DESCRIPTIVE REPORT

Type of Survey Hydrographic
Field No. RA-10-07-99
Registry No. H-10870

State Alaska
General Locality Lynn Canal
Sublocality Saginaw Channel and Barlow Cove

Descriptive Report to Accompany Hydrographic Survey H10870

Figure 4 – Prior Surveys

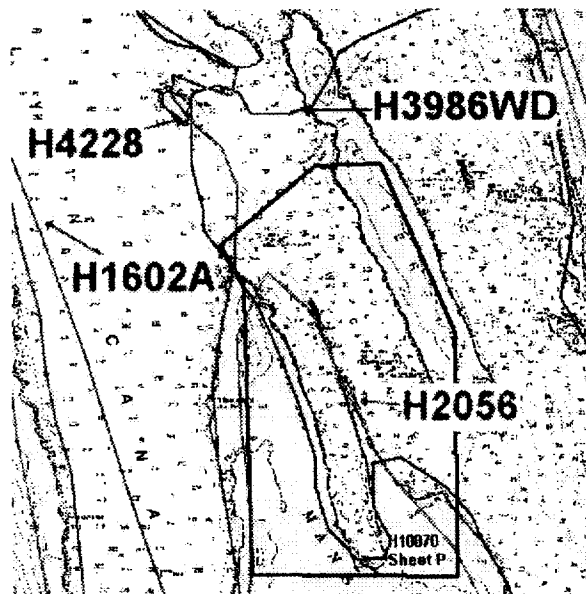
Prior survey soundings were found to be in fair agreement with those from the current survey. Least depths over shoals and features from the current survey were generally shoaler than, or in agreement with prior surveys. This is primarily attributable to increased bottom coverage and horizontal accuracy obtained with modern positioning and sounding equipment. *Concur.*

Prior survey H1602A has soundings generally in agreement with current survey soundings. ^{current.} The soundings from this prior, however, are only given for the areas around Adam's Anchorage at the southern end of Shelter Island, the cove just northwest of Symonds Point, and the southern end of Barlow Cove.

Figure 5 – Discrepancy between prior survey H2056 and current survey soundings.

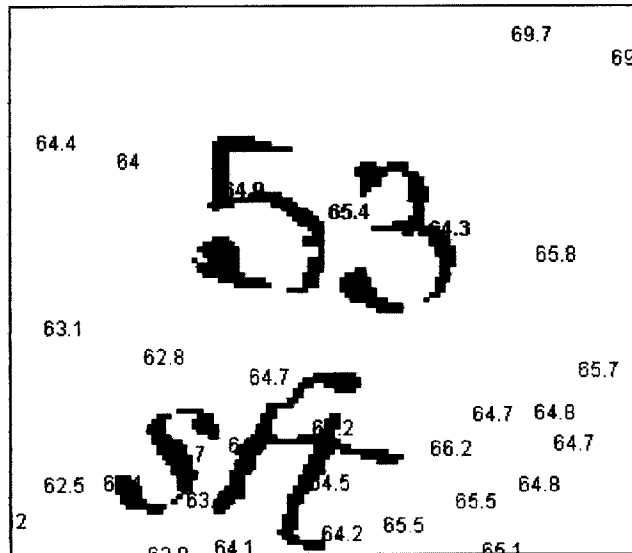
Prior survey H2056 covers the bulk of H10870 and supplies the largest number of prior soundings that correspond with the current project. Most of the soundings for prior H2056 are in good agreement. Where soundings were in disagreement, current survey soundings were usually shoaler by no more than 1 or 2 fathoms. One major disagreement, however, is that of a prior sounding of 53 fathoms located at 58°26'00"N, 134°55'29"W, which corresponds to an area of 65-fathom soundings from the current survey project (Pos. # 30220 - 30222). The difference is shown in Figure 5. *(Chart the area based on the latest survey.)*

Figure 6 – AWOIS 52409 investigation site in Barlow Cove with location of new reef. ✓

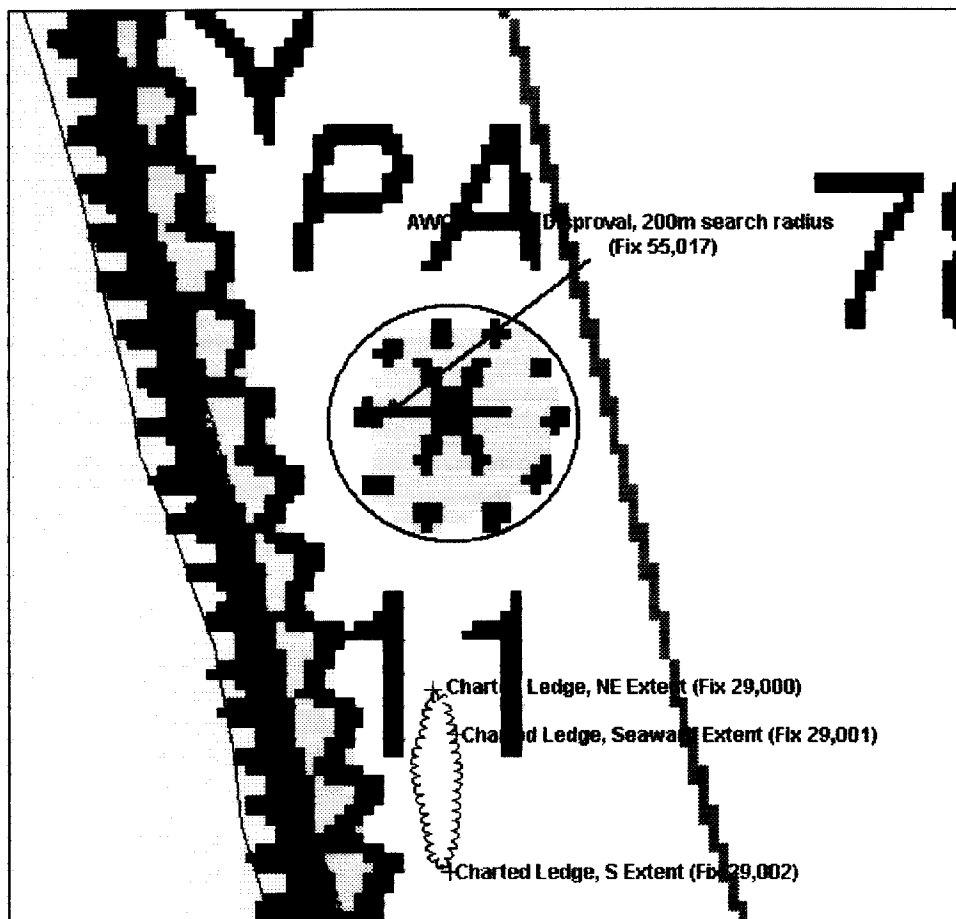
AWOIS 52409 was disproved after conducting the 200 meter search radius investigation. However, it should be noted that a new reef (refer to Pos. # 29,000 – 29,002) was found approximately 200 meters south of the reported area. Figure 6 illustrates the findings below:

AWOIS 52409 was compared to Chart 17316 (18th Edition; 7/18/98; 1:80,000). The Hydrographer recommends removing the rock awash symbol ^(PA) (at 58°21'41"N, 134°54'16"W) from Chart 17316. *CONCUR . Chart the area based on the present survey .*

Figure 8 – Chart 17316 Sounding Discrepancies

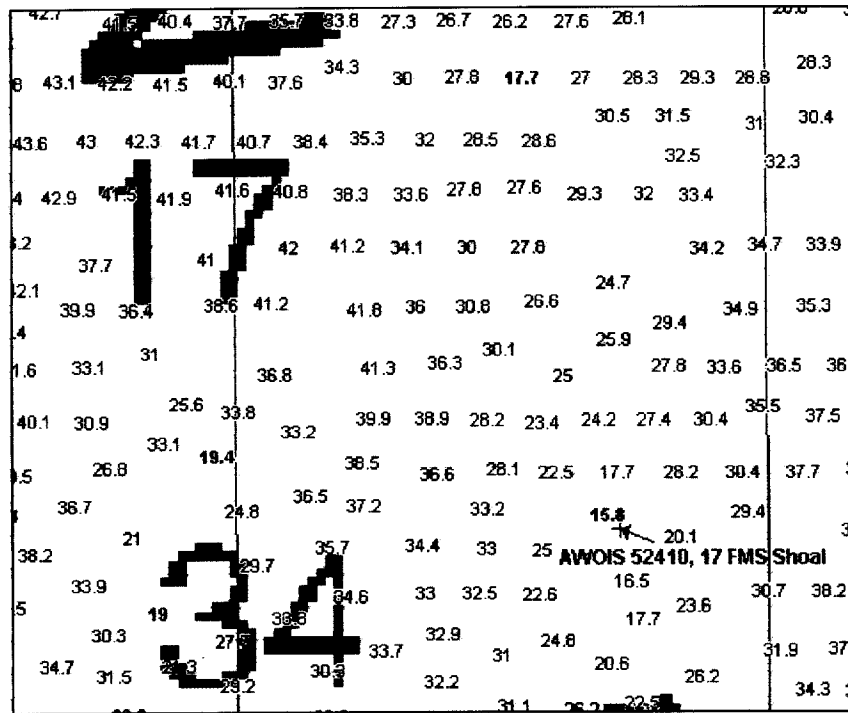
Significant discrepancies were noted particularly in the southern end of Saginaw Channel. This includes the shoal area NW of Symonds Point at the lower end of Saginaw Channel which had discrepancies of 5 fathoms, including two Dangers To Navigation (DTON) which are discussed below. Additionally, a 19 fathom shoal found at 58°22'04"N, 134°52'0"W and a 19.4 fathom sounding found at 58°22'09"N, 134°51'57"W, are near a charted 34 fathom sounding approximately 1000 meters south of Favorite Reef. In this same location the charted 17 fathom sounding is approximately 300 meters west from the location of the 17 fathom sounding found during this survey. *Compare* Figure 8 below illustrates this discrepancy:
